**Subject: PACIFIC GAS AND ELECTRIC COMPANY'S PETITION FOR  
AMENDMENT  
GATEWAY GENERATING STATION  
DOCKET NO. (00-AFC-01C)**

# PETITION FOR AMENDMENT

GATEWAY GENERATING STATION (00-AFC-1C)

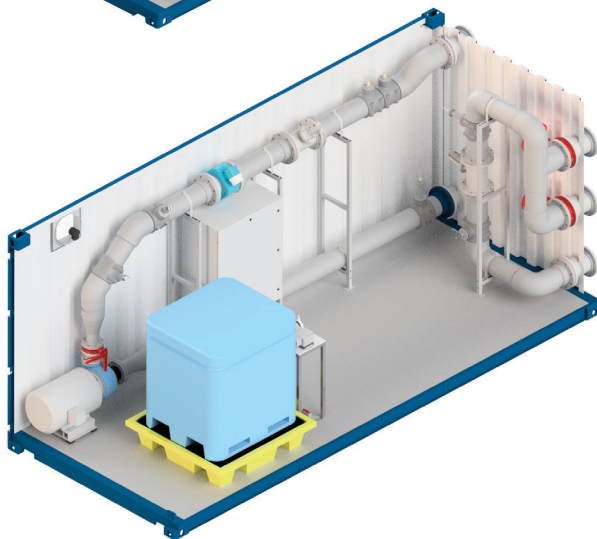
Figure 1, Site Plan shows the proposed location of the new storm water treatment equipment. The new equipment will be located immediately adjacent to the existing concrete basin used to collect site storm water before it is discharged to the river. This existing basin is identified as Sampling Point E006 in the GGS Storm Water Pollution Prevention Plan. The location for the equipment was previously graded during construction and is paved as well as graveled.

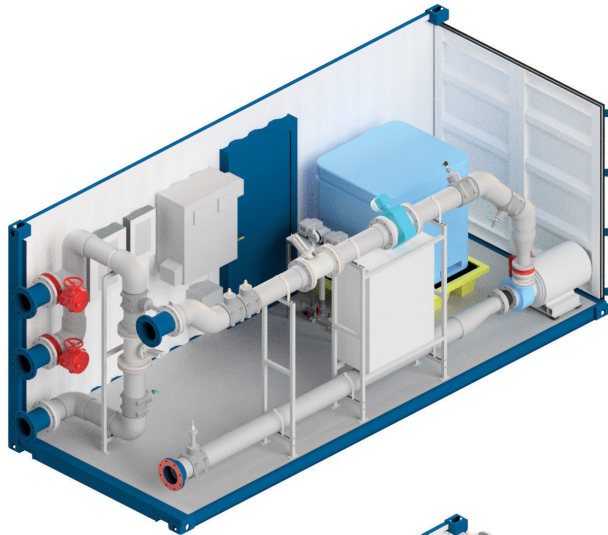
Figure 2, Project Layout, shows the location of the equipment with each feature labeled “A” through “H”. The area labeled “A” is the existing concrete storm water collection basin. The concrete basin has a sump and discharge pump. The area labeled “B” is the source tank which will receive the storm water collected in the existing concrete basin and has a capacity of 20,000 gallons. Area “C” will contain the Treatment System Module, which will be housed in a Conex-type container. Figure 3 is a photograph of the Treatment System Module. Area “E” contains a 20,000 gallon settling tank. The area labeled “G” contains the Media Filter Assembly, a photograph of which is shown in Figure 4.

To describe each step in the treatment process, Figure 2 uses the labels “A” through “H”.
